ROBINSON NUCLEAR PROJECT

PLANT MODIFICATION M-958

ADD AUTO START TO "B" SI PUMP

SAFETY EVALUATION FOR M-958  
"ADD AUTO START TO 'B' SI PUMP"

CAROLINA POWER & LIGHT CO. H.B. ROBINSON STEAM ELECTRIC PLANT			
				SAFETY RELATED			
				CONTROL WIRING DIAGRAM			
REV NO.	DATE	DESCRIPTION	DRAWN BY	CHK'D	RV'ND	APPRV.	REF. DWG. B-190628 SHT 896, REV. 14
A	14 JUNE 88	ISSUED FOR MOD 958	JM	RE	AC		SKETCH NO. SK-958-Z-7001

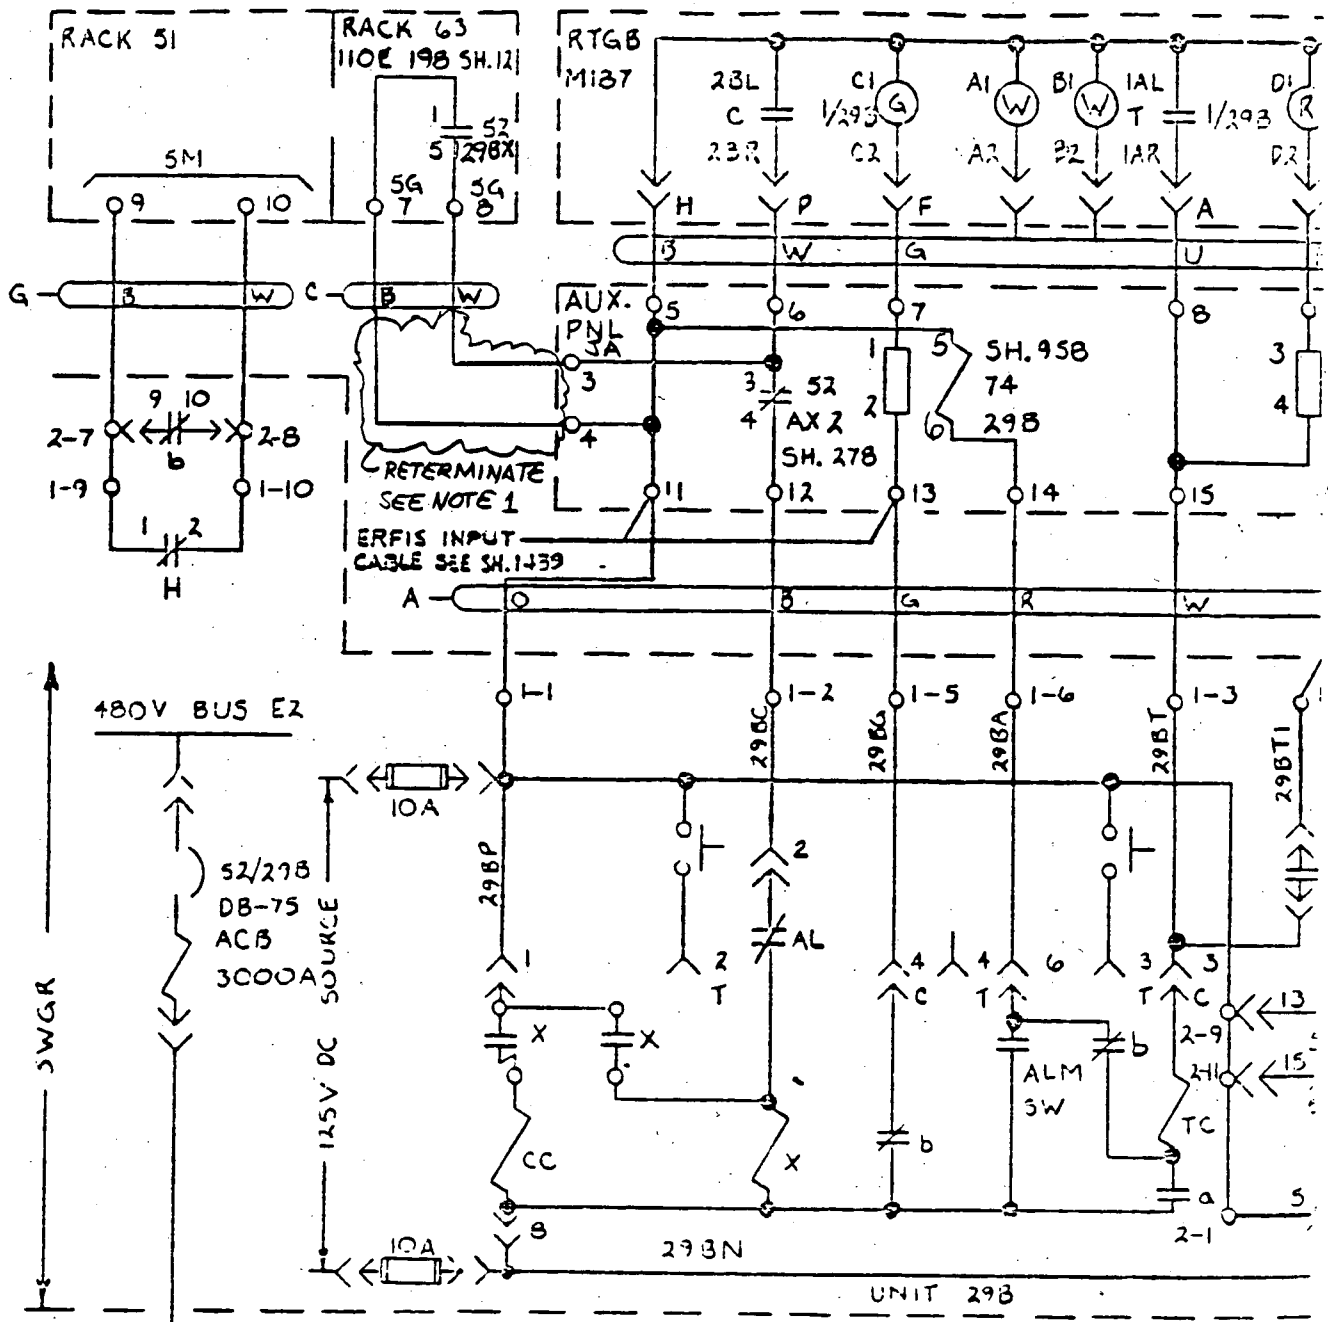
NOTE 1: CABLE C2896C WAS DETERMINED AND LABELED SPARE PER MOD-951.  
RETERMINATE THIS CABLE ON AUX PANEL JA AS SHOWN.

SKETCH NO. SK-958-Z-7006

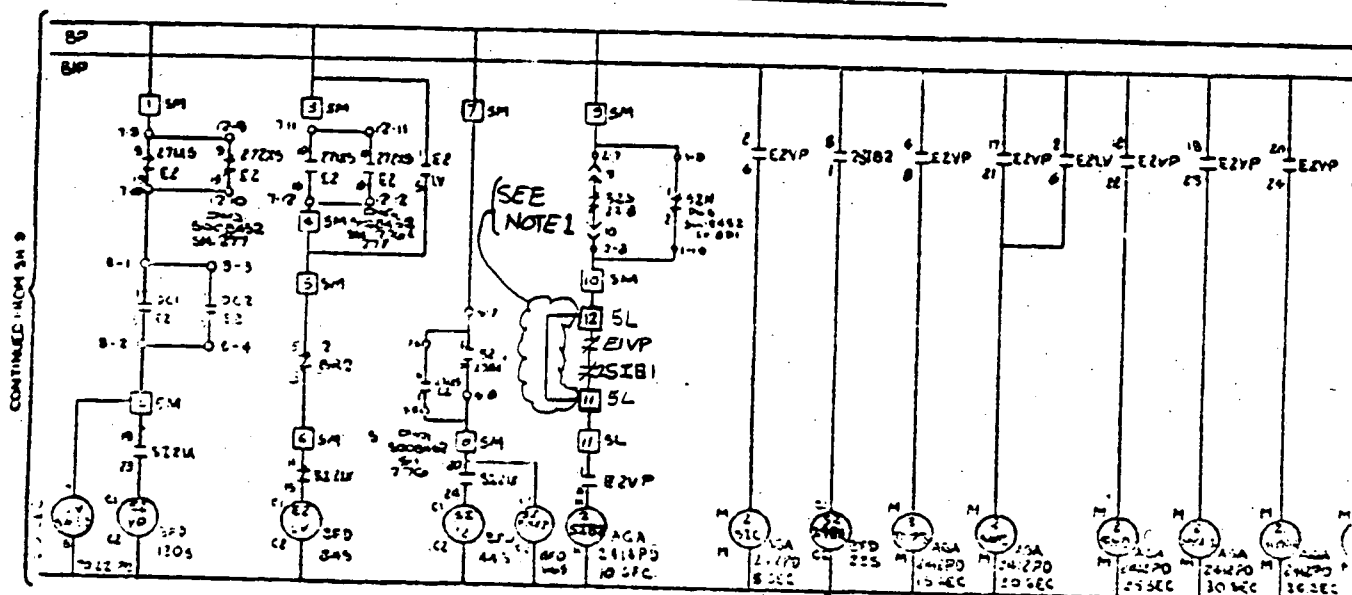
NOTE 1: INSTALL A JUMPER BETWEEN TERMINALS SM-11 AND SM-12 IN SAFEGUARDS RACK NO. 51 AND A JUMPER BETWEEN TERMINALS 5L-12 AND 5L-11 IN SAFEGUARDS RACK NO. 63 AS SHOWN.

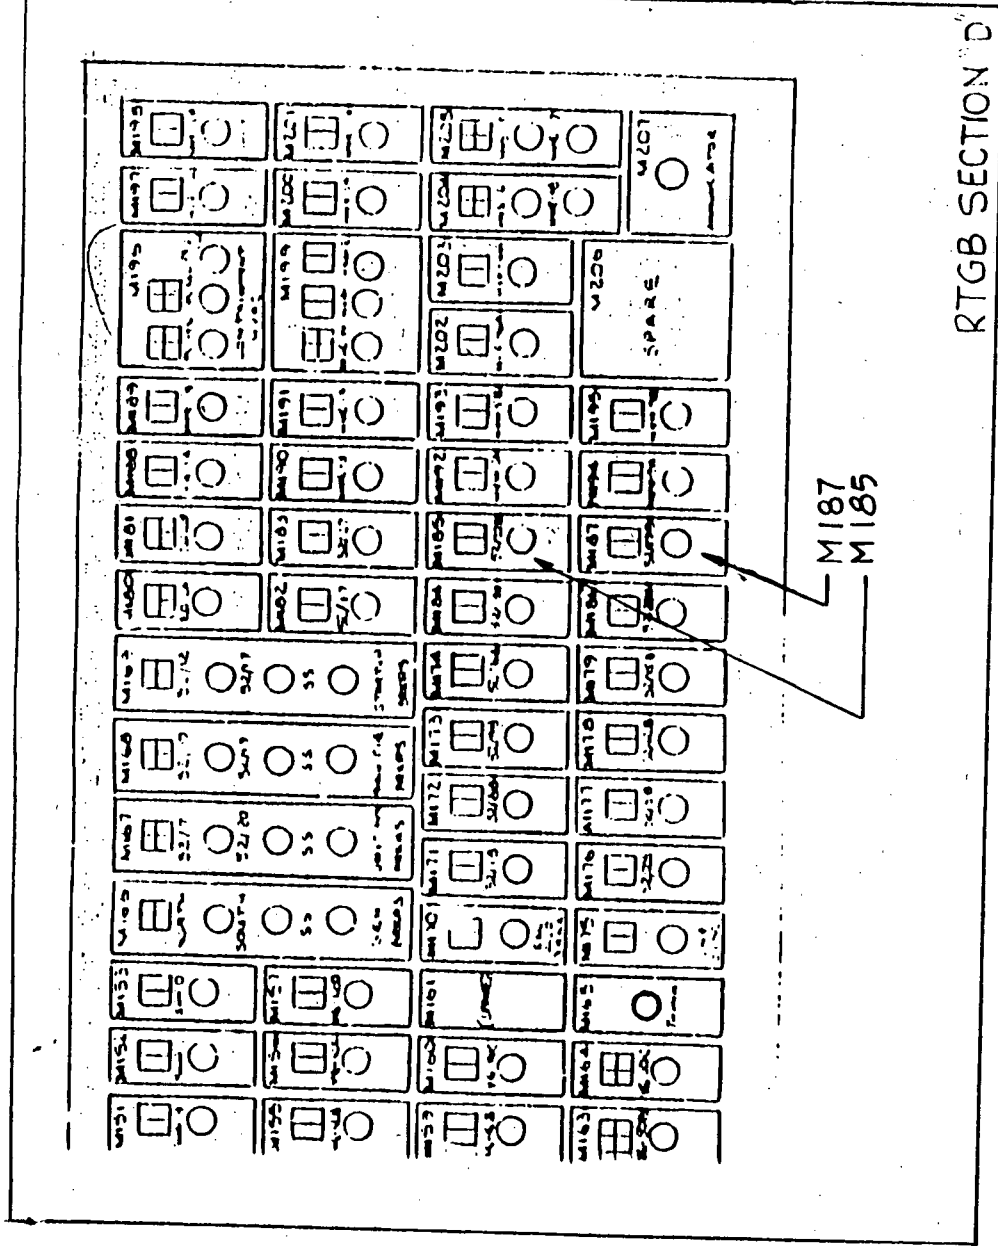
- 5.5.4 Remove Module M187 and disconnect selector switch and pilot lights as detailed in Sketch SK-958-Z-7009. Install a blank faceplate on Module M-185 (B/M Item No. 12) and reinsert Module M-187 in RTGB.

1. SEE SK-958-Z-7011 FOR LOCATION OF M187.
2. DISCONNECT CABLE C2896B FROM CONNECTOR OF M187. CABLE WILL BE SPLICED AND USED LATER.
3. DISCONNECT INTERNAL WIRING FROM SELECTOR SWITCH. REMOVE SELECTOR SWITCH FROM M187. SELECTOR SWITCH WILL BE INSTALLED IN M35 LATER.
4. REMOVE MODULE M187 FROM PANEL AND INSTALL PLATE OVER CUT-OUT.

REV. NO.	DATE	DESCRIPTION	DESIGNED BY	CHECKED BY	APPROVED	CAROLINA POWER & LIGHT CO. H.B. ROBINSON STEAM ELECTRIC PLANT
SAFETY - RELATED						SWGR. EMERG. BUS E2 CUB 29B WIRING REMOVALS
REF. CUG.						
SKETCH NO. SK-958-Z-7016

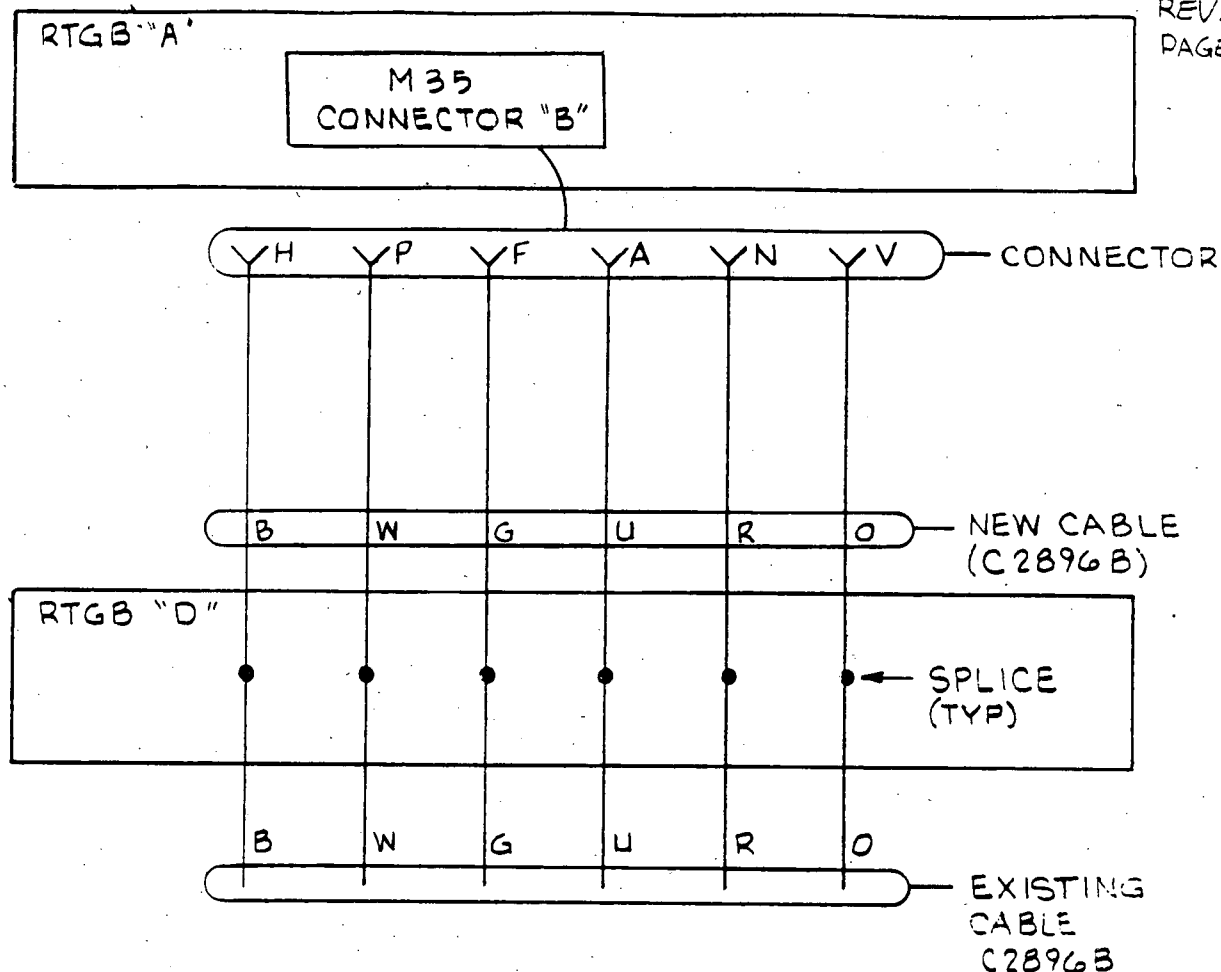
- 5.6.2 Remove wires from Breaker 52/29B as detailed in Sketches SK-958-Z-7016 and SK-958-Z-7017.

1. FOR LOCATION OF SHUNT RELAY (TC-2) SEE SK-958-Z-7017 DISCONNECT & REMOVE WIRING FROM TC-2 TO 52A CONTACT -5 AND MOVING CONTACT -11. REMOVE TC-2.
2. REMOVE WIRE/CABLE AND CONDUIT

CAROLINA POWER & LIGHT CO. H.B. ROBINSON STEAM ELECTRIC PLANT			
				SAFETY- RELATED			
				SWGR. EMERG. BUS E, CUB. 22B WIRING REMOVALS			
REV. NO.	DATE	DESCRIPTION	DATE	BY	CHK'D	REV'D	APPROV.
A	88 AUG. 25	PM 958					
				REF. DWG.			
				SKETCH NO. SK-958-Z-7019

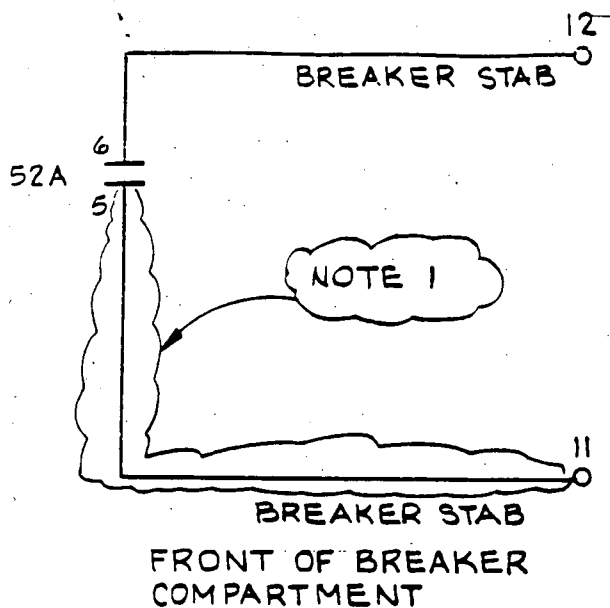
- 5.6.5 Remove wires from Breaker 52/22B as detailed in Sketches SK-958-Z-7019 and SK-958-Z-7017.

1. FOR LOCATION OF SHUNT RELAY (TC-2) SEE SK-958-Z-7017. DISCONNECT & REMOVE WIRING FROM TC-2 TO 52A CONTACT 5 AND MOVING CONTACT - 11. REMOVE TC-2.
2. REMOVE WIRE/CABLE AND CONDUIT

CAROLINA POWER & LIGHT CO. H.B. ROBINSON STEAM ELECTRIC PLANT			
				SAFETY RELATED			
				SWGR EMERG BUS E2 CUB. 27A MODIFICATIONS			
REV. NO.	DATE	DESCRIPTION	THRU	BY	IN	APPROV.	REF. DWG.
A	89 AUG 28	PH 958	WJG	WJG	WJG	WJG	SKETCH NO. SK-958-Z-7023

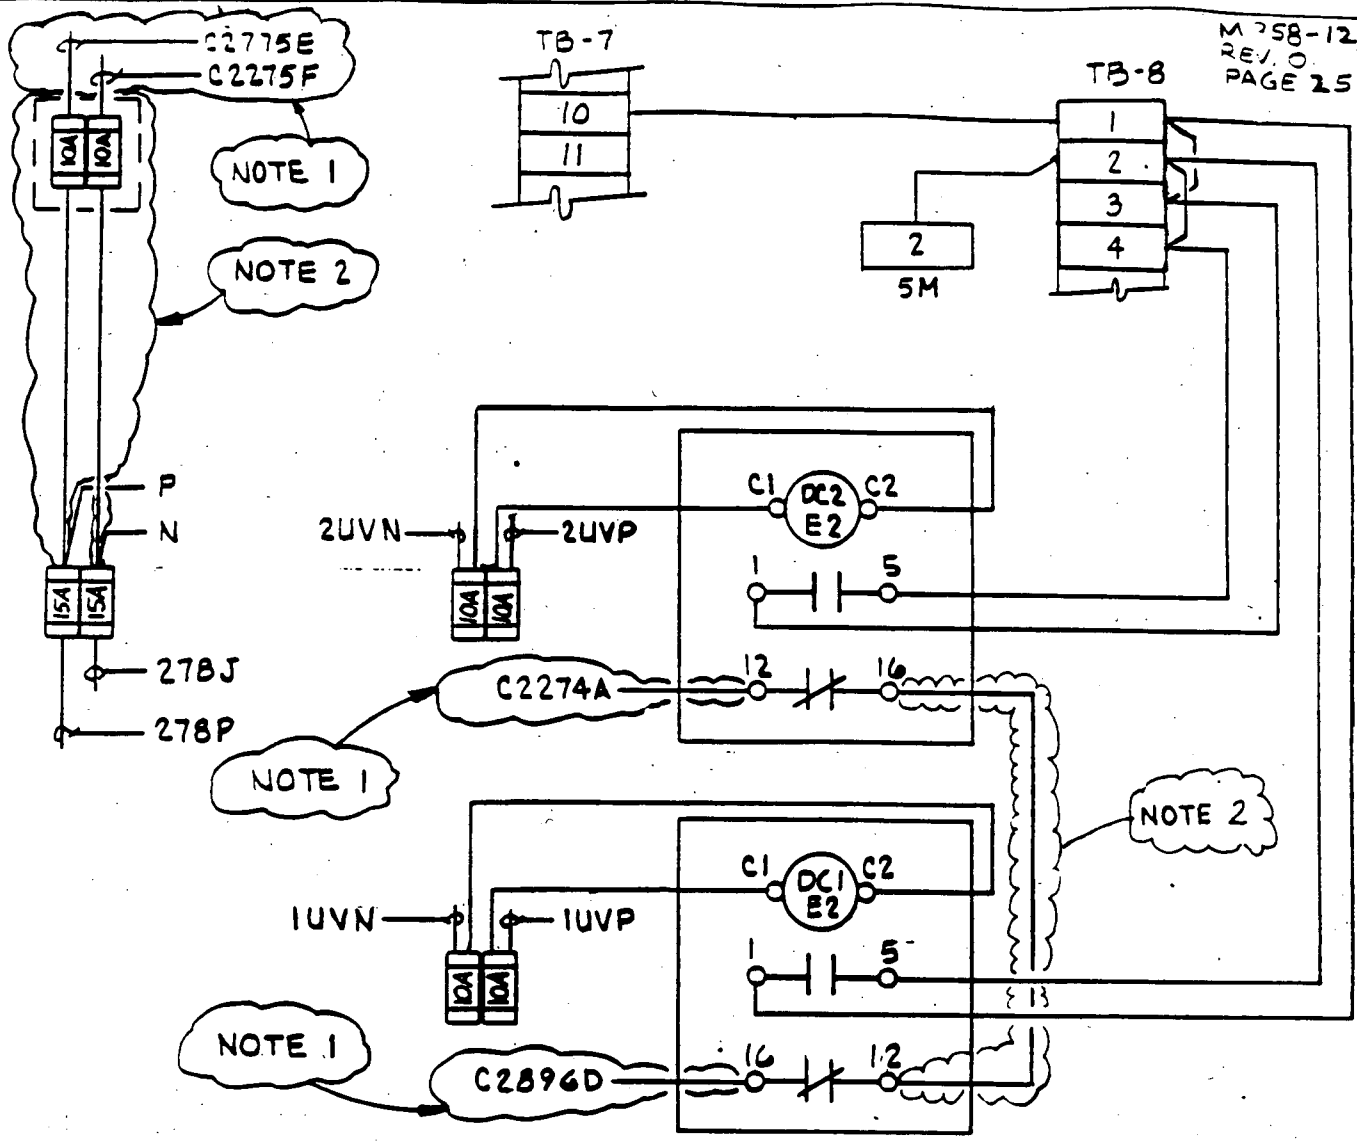
1. SEE DWG. SK-958-Z-7022 FOR DEVICE LOCATIONS. DISCONNECT, PULL BACK & REMOVE THESE CABLES AND THEIR CONDUITS.
2. DISCONNECT AND REMOVE WIRING, FUSES & JUMPER AS SHOWN WITHIN CLOUD. ENSURE THAT EXISTING WIRING WHICH IS TO REMAIN, IS SECURE.
3. JUNCTION Box # 206 MAY BE LEFT IN PLACE.

CAROLINA POWER & LIGHT CO. H.B. ROBINSON STEAM ELECTRIC PLANT			
				SAFETY RELATED			
				SWGR. EMERG. BUS EI CUB. 17A MODIFICATIONS			
A <sup>98</sup> <sub>25</sub> PH 958				REF. DWG.			
REV. NO.	DATE	DESCRIPTION	INITIALS	BY	DATE	APPROVED	DATE
				SKETCH NO. SK-958-Z-7024

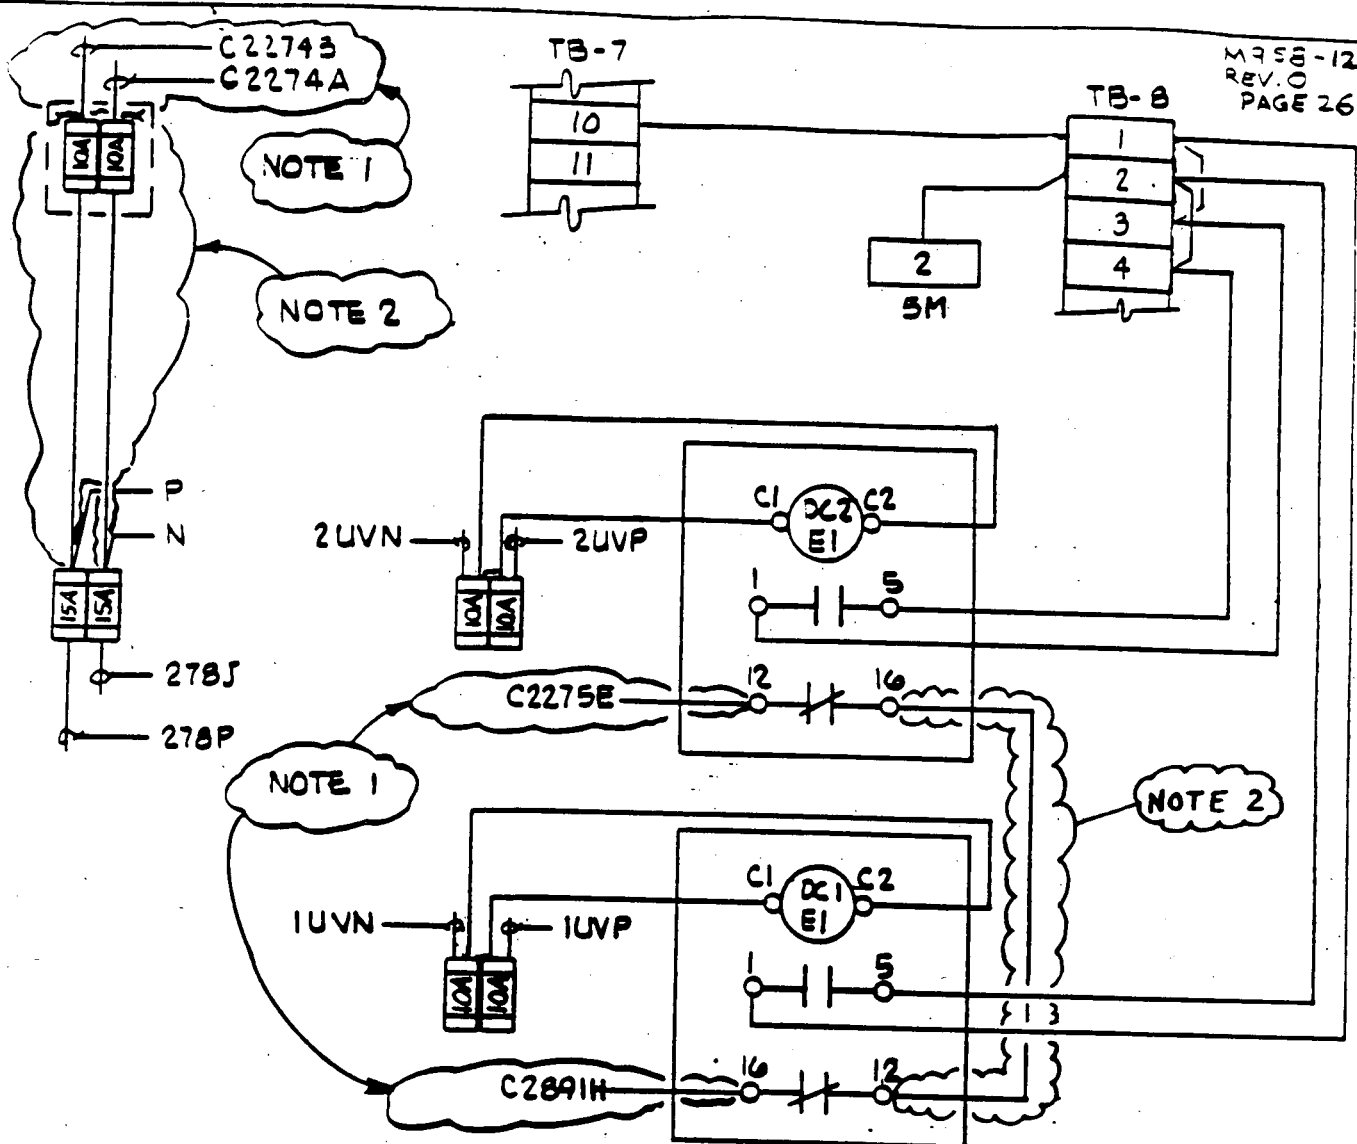
- NOTES:**
1. SEE DWG. SK-958-Z-7021 FOR DEVICE LOCATIONS. DISCONNECT, PULL BACK & REMOVE THESE CABLES AND THEIR CONDUITS
  2. DISCONNECT AND REMOVE WIRING, FUSES & JUMPER AS SHOWN WITHIN CLOUD. ENSURE THAT EXISTING WIRING WHICH IS TO REMAIN, IS SECURE.
  3. JUNCTION BOX #207 MAY BE LEFT IN PLACE.

CAROLINA POWER & LIGHT CO. H.B. ROBINSON STEAM ELECTRIC PLANT			
				SAFETY-RELATED			
				+80V SWGR. CABLE INSTALLATION/TERMINATIONS			
A	88 AUG 25	PM 958		DESIGN BY	CHK'D	REV'D	APPROV.
REV'D	DATE	DESCRIPTION					
				REF. CNG.			
				SKETCH NO. SK-958-Z-7025

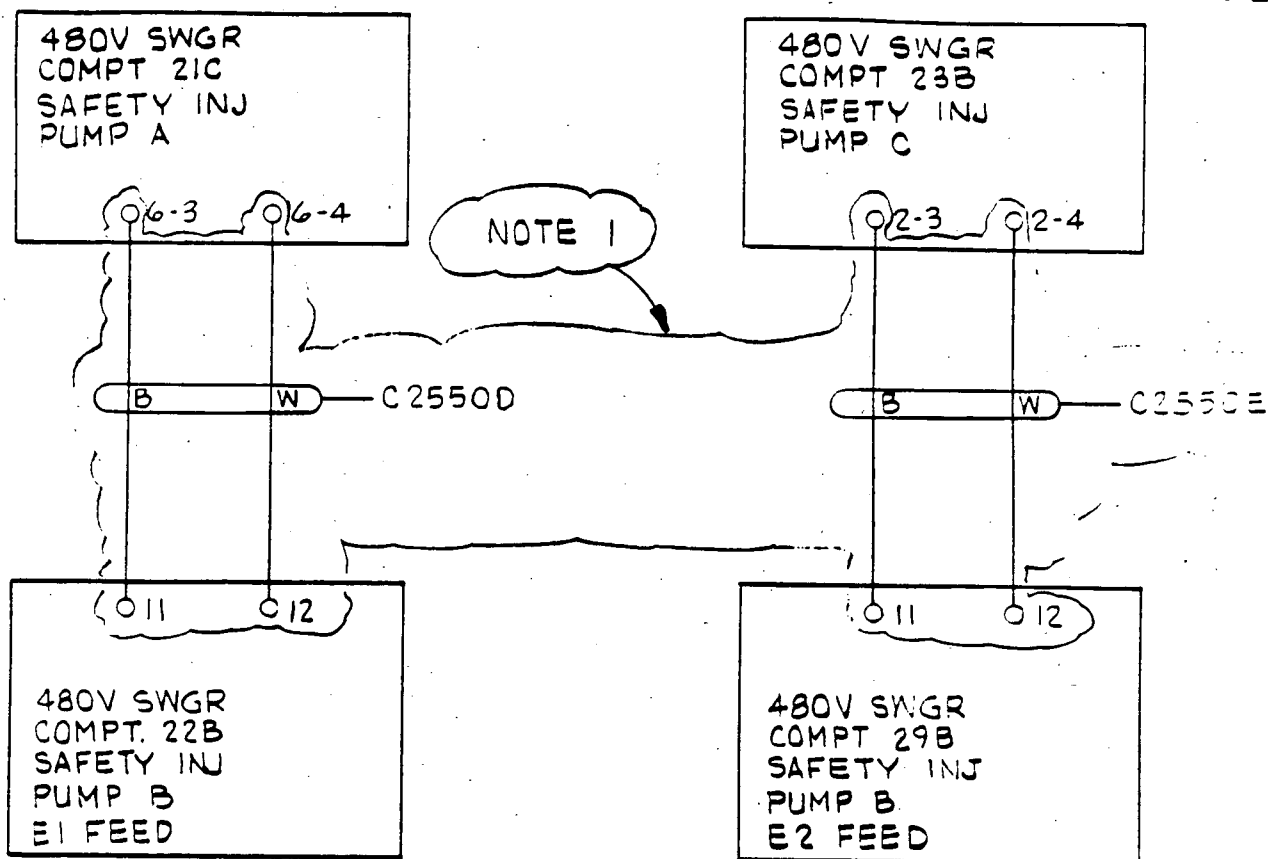
1. INSTALL CABLES BETWEEN COMPARTMENTS AS SHOWN, UTILIZING EXISTING TROUGHS & WIREWAYS. TAG CABLES AS SHOWN.

CAROLINA POWER & LIGHT CO. H.B. ROBINSON STEAM ELECTRIC PLANT			
				SAFETY - RELATED			
				480V SWGR WIRE REMOVAL			
REV NO	DATE	DESCRIPTION	DRAWN BY	CHECKED BY	REV'D BY	APPROVED BY	REF. DWG.
A	25	PM 958	WLG	RAE	RAE	RAE	B-190628 SMT 550 REV. 2
							SKETCH NO. SK-958-Z-7026

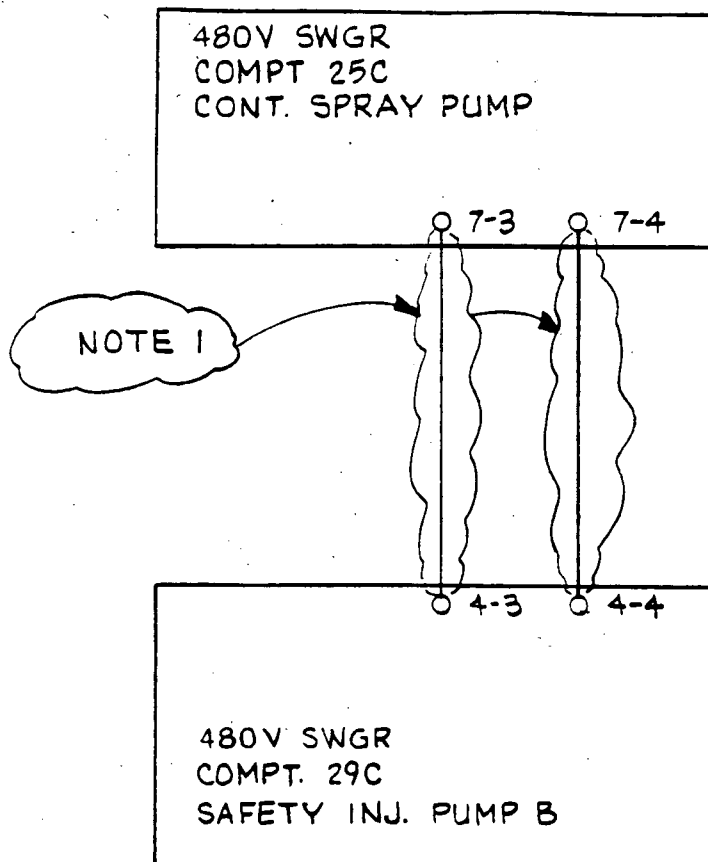
5.8.3 Remove wires that run between E2 Bus Compartments 25C and 29C  
as detailed in Sketch SK-958-Z-7026.

- I. DISCONNECT BOTH ENDS OF CABLE. TAPE BACK AND SPARE.

CAROLINA POWER & LIGHT CO. H.B. ROBINSON STEAM ELECTRIC PLANT			
				SAFETY - RELATED			
				"B" SI FEEDER BREAKER 52/29C AMPTECTOR DISABLE			
REV. NO.	DATE	DESCRIPTION	CHANGED BY	CHANGED BY	REV. NO.	DATE	DESCRIPTION
A	AUG 88	PM-958	WLB	WLB			
							REF. CHG.
				SKETCH NO. SK-958-Z-7027

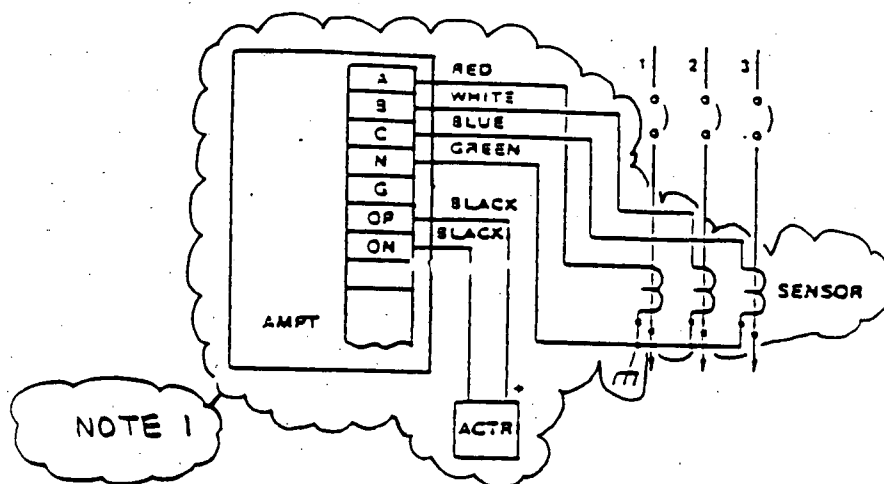
- 5.10.1      Remove the amptector wiring, amptector, current sensors, and  
            ACTR on Breaker 52/29C as detailed on Drawing SK-958-Z-7027.
